DART SERVICE INSTRUCTION

TO AMEND INSTALLATION INSTRUCTIONS IIN-D206-667 REV. C AND INSTRUCTIONS FOR CONTINUED AIRWORTHINESS ICA-D206-667 REV. 2

REF: CANADIAN STC: SH01-5 REF: FAA STC: SR01304NY

CROSSTUBE SUPPORT CHANGE
COPYRIGHT © 2008 BY DART AEROSPACE LTD

FIGURE 1 - CROSSTUBE SUPPORT

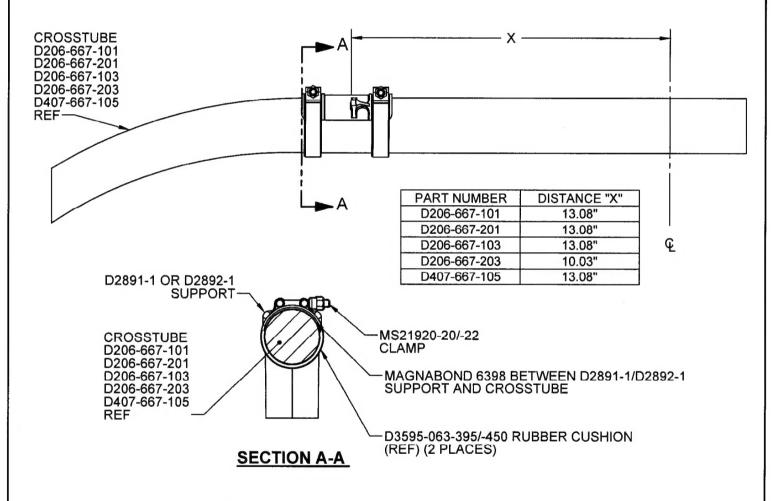
- 6) Apply a 0.03" to 0.06" thick layer of Magnabond 6398 underneath the D2891-1/D2892-1 support and re-install the support on the crosstube as shown in Figure 1. Position and secure the D2891-1/D2892-1 support on the crosstube using MS21920-20/-22 Clamps. Install a D3595-063-395/-450 Rubber cushion underneath each MS21920-20/-22 Clamp. Torque clamps 80-100 in-lb. Let the D206-667-101/-201/-103/-203 or D412-667-105 crosstube assembly cure as per the Magnabond 6398 instructions before re-installing the crosstube on the aircraft.
